This page lists the know errors on the gm5x5x5 PCBs.

Prototype Run

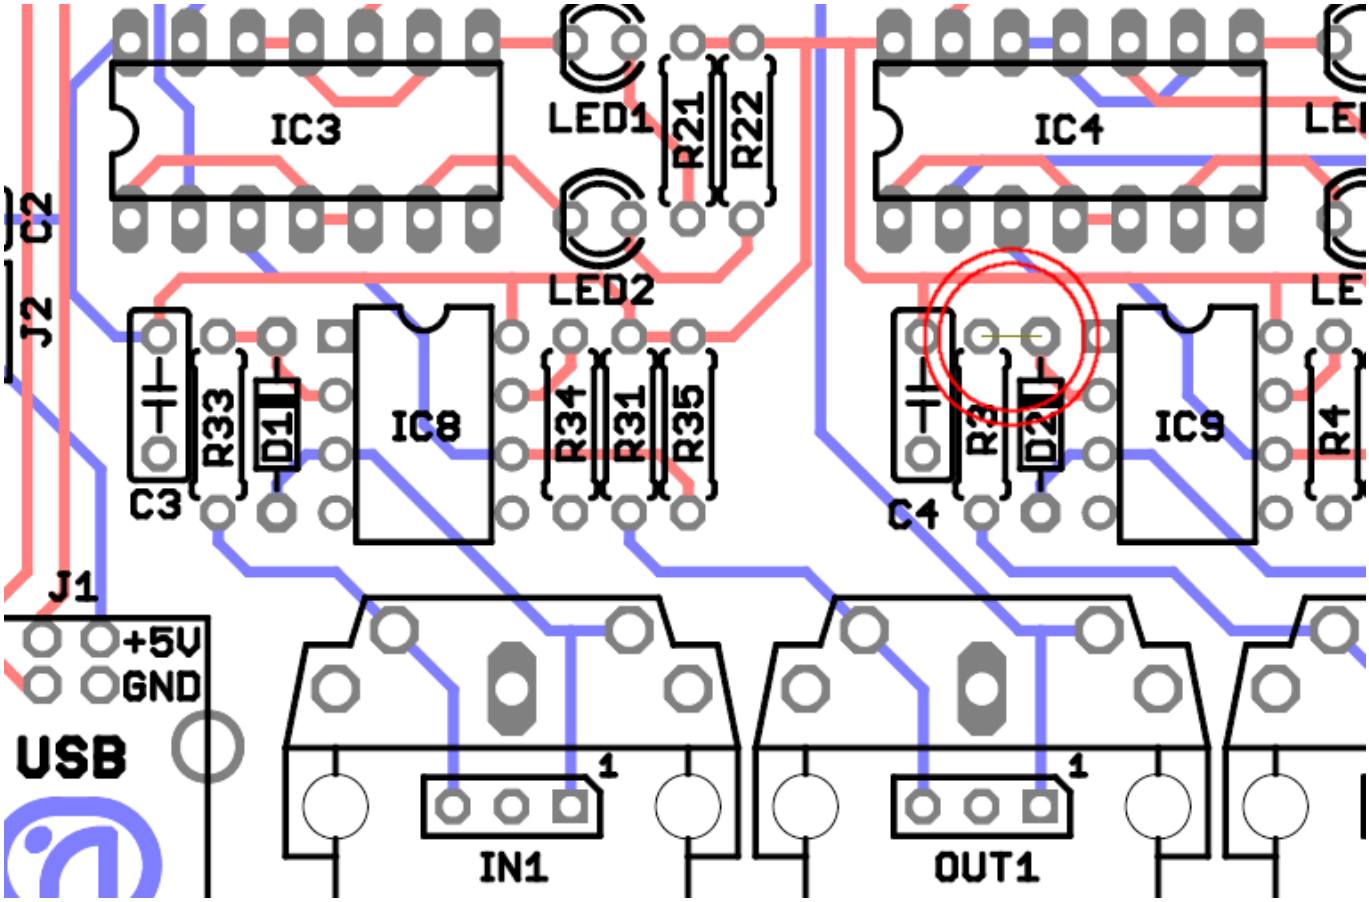
#1 MIDI IO pins

Problem: The MIDI IO pins of the midi sockets (Pin 4 + 5) are switched.

Solution: Either (1) use the pin-headers if you use sockets that are not mounted on the pcb or (2) break the traces to pins 4 + 5 of the sockets and solder wires to them or (3) solder the midi sockets on the other side of the pcb.
